Seat Bottom, LH/RI

DART AEROSPACE LTD HAWKESBURY, ONTARIO, CANADA DRAWING NO. REV. B D3774 SHEET 1 OF 3 TITLE SCALE SEAT

Subject: RE: Manufacturing Polycarbonate

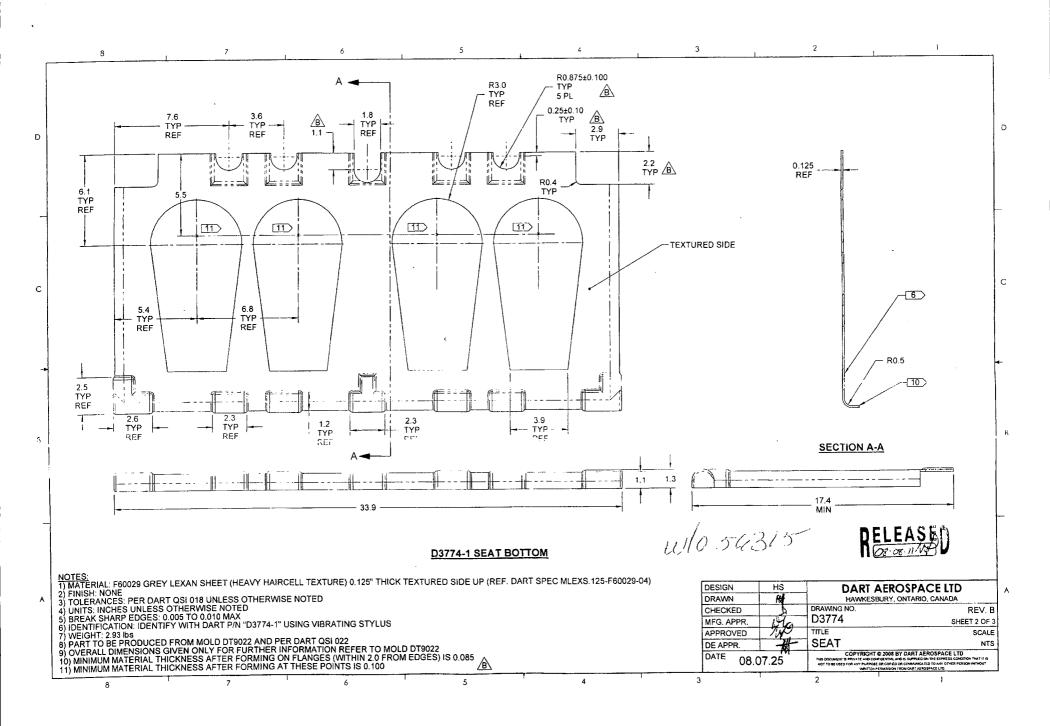
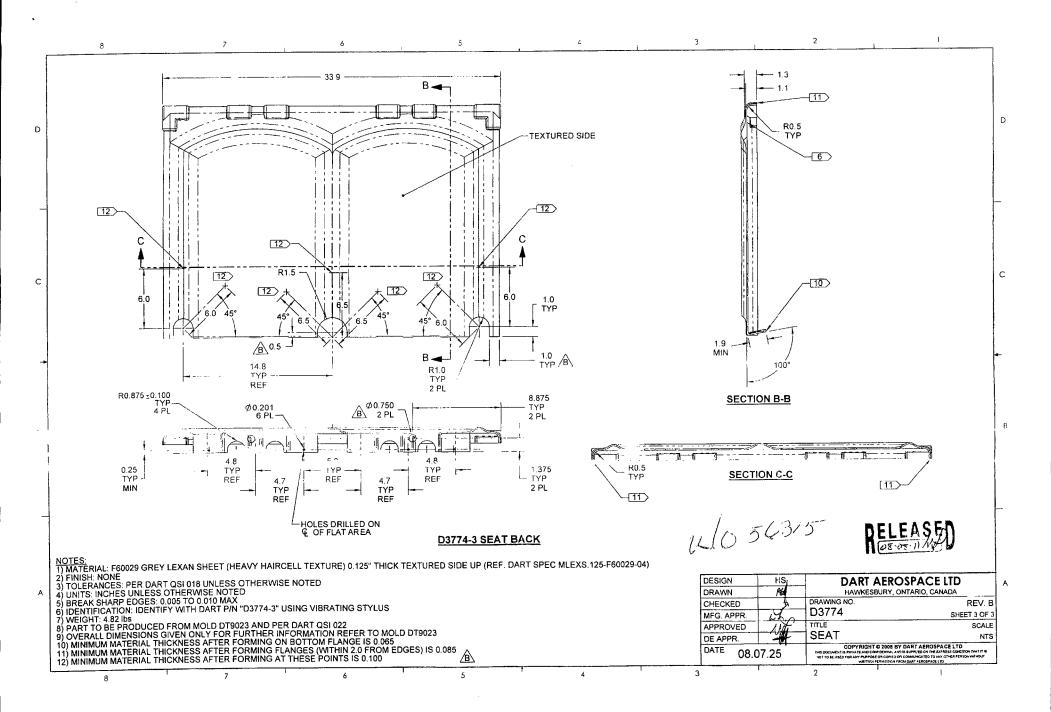
Linda is in dire need for at least 1 D3774-1 aft facing seat bottom. We have an order for 4 so I would like to make a total of 5.

Because we have had discussion on parameters for manufacturing and have a sense of where we want to be with this, I would like to produce these for her tomorrow morning using the outlined parameters listed below.

We will dry the 0.125" lexan sheet at the recommended temperature of 255 deg. F., overnight for 15hrs. (The recommended time 2/24/2010

We will form them on a mould preheated to approx 240deg.F., then cool without fans to a surface temperature of approx. 270 deg. F. at which time they will be parted from the mould.

I'm OK with making the seat bottoms, the existing folio should be followed.

Should record:

Drying

- The time when sheets were placed in the oven

Temperature

Time when removed

Forming

Time when sheet formed

- Mold Temp

Sheet Temp just before molding

Release Temp
